### Addendum No. 1

**City of Coquitlam  
Tender 77801  
3371 Mason Ave Frontage Improvements**

Issue Date: January 18, 2022

Project **MASON AVE  
HOLLYBROOK ST TO COAST MERIDIAN RD**  
Description **ROADWORKS - PLAN & PROFILE**  
File: 20-1027-4-R3  
REV. **6**

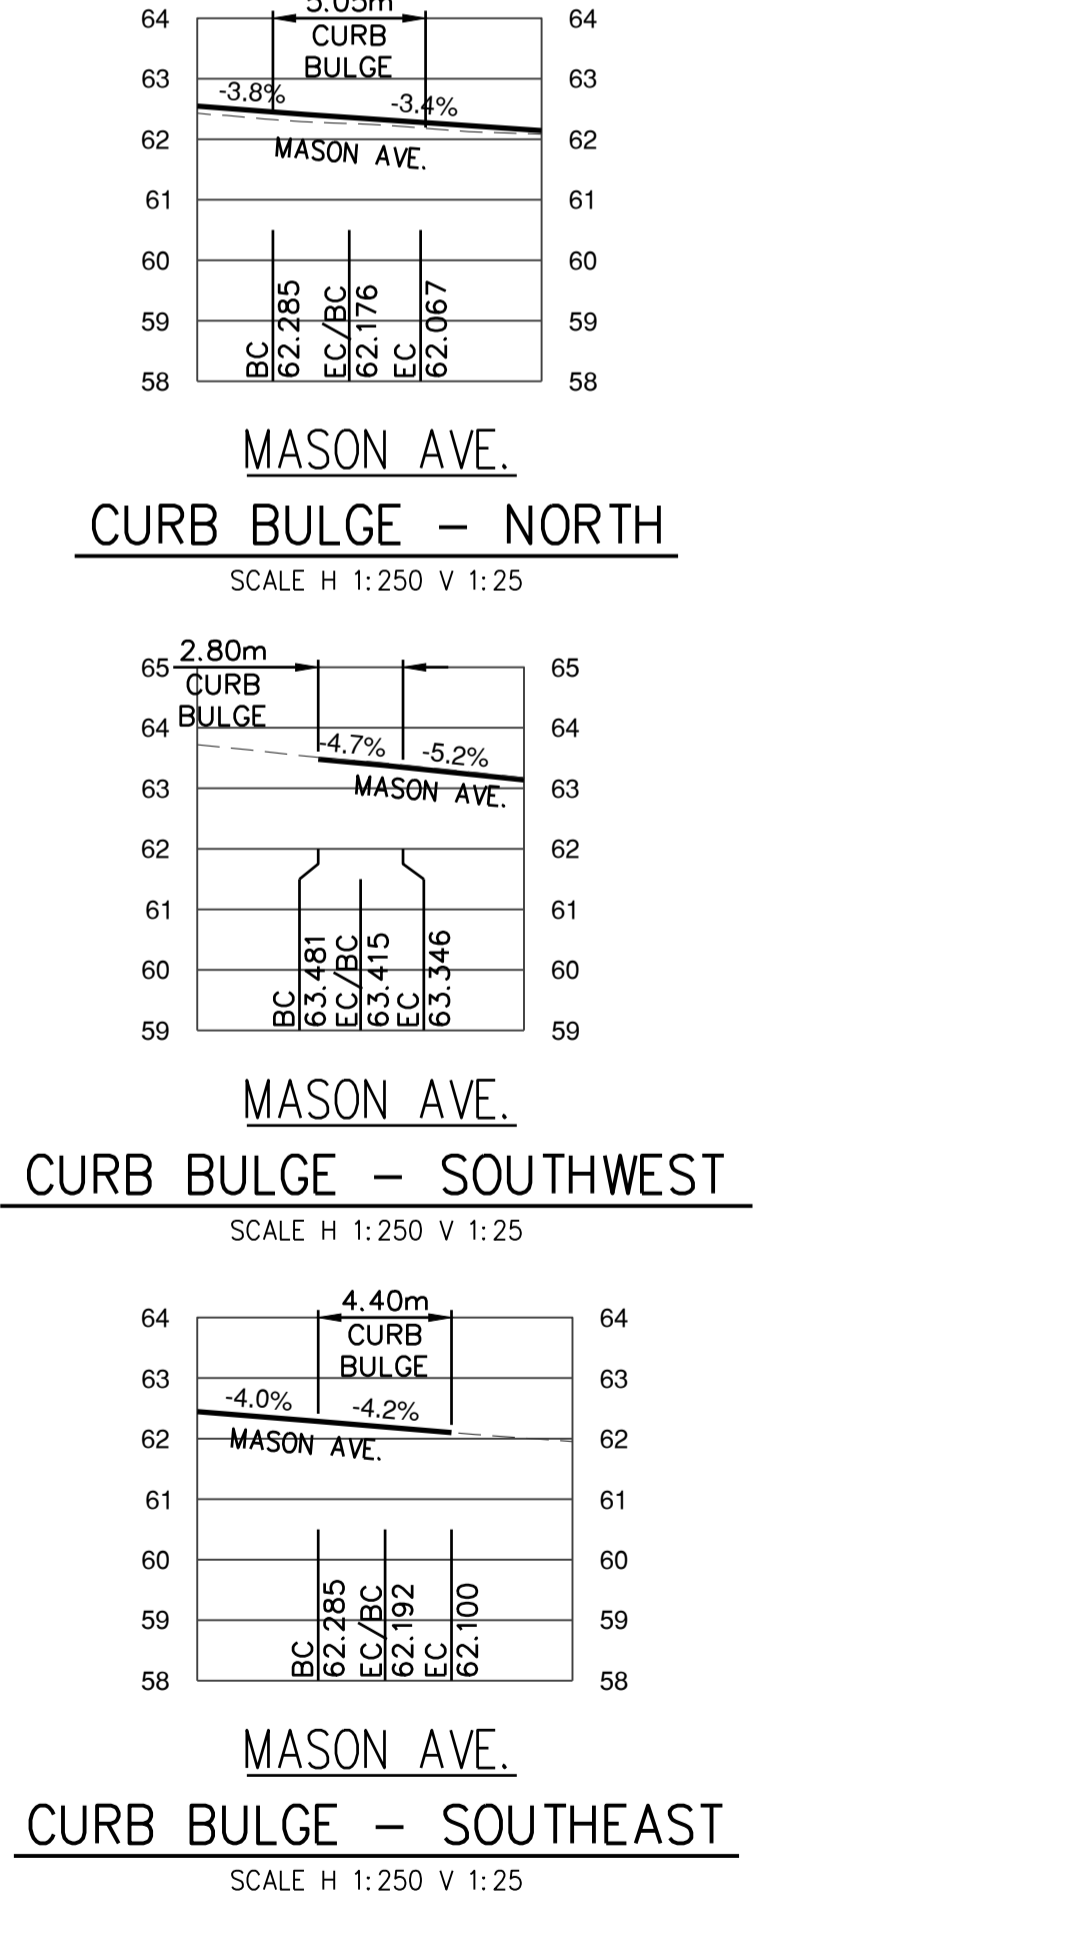
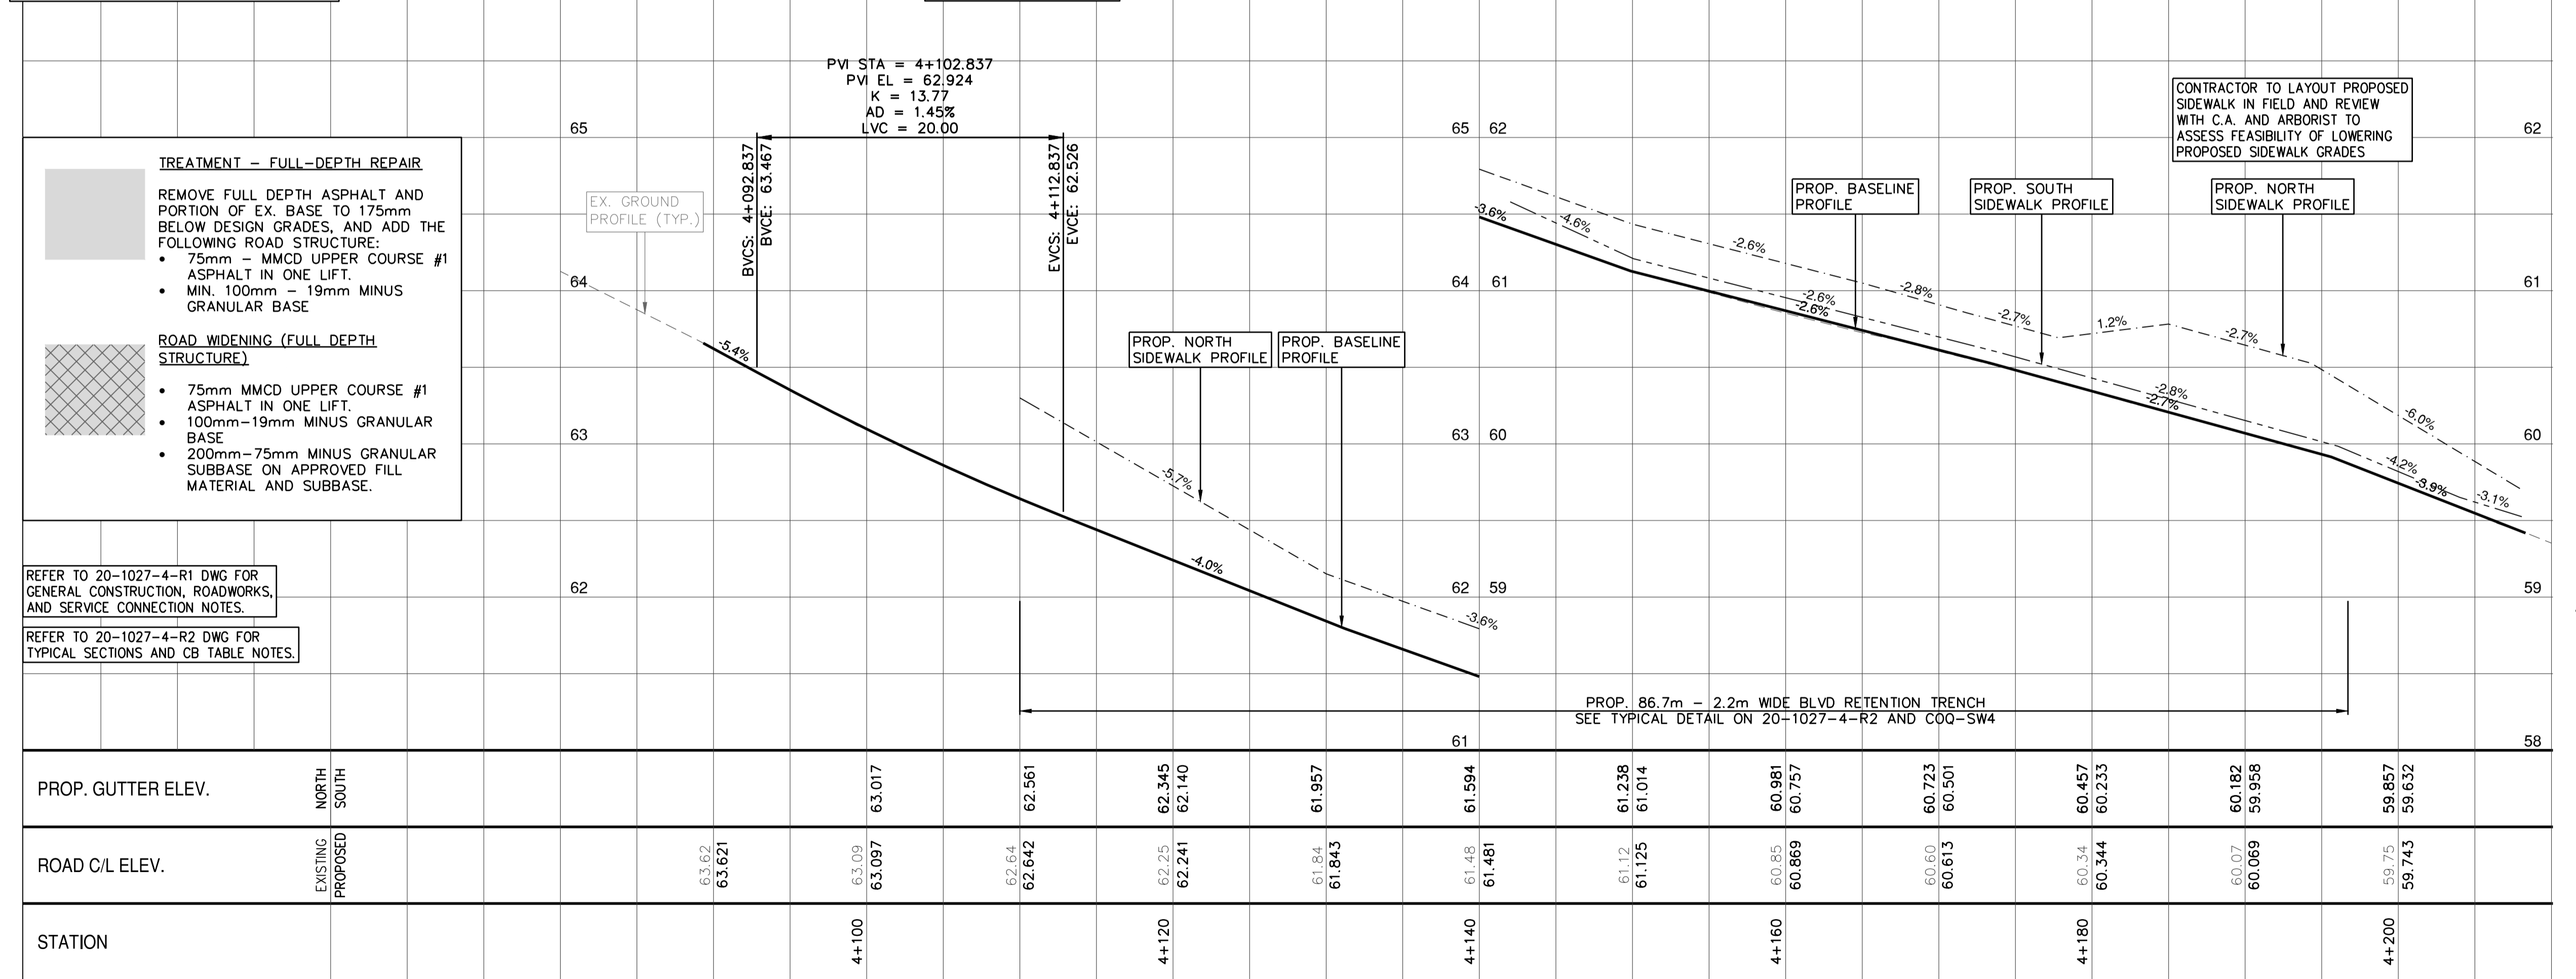
- A10) The two storm leads shall be connected to the storm main to the south. The new water service shall be connected to the 150mm watermain to the south. Refer to Sheets 3 of 12, Rev. 6 and 10 of 12, Rev. 5.**
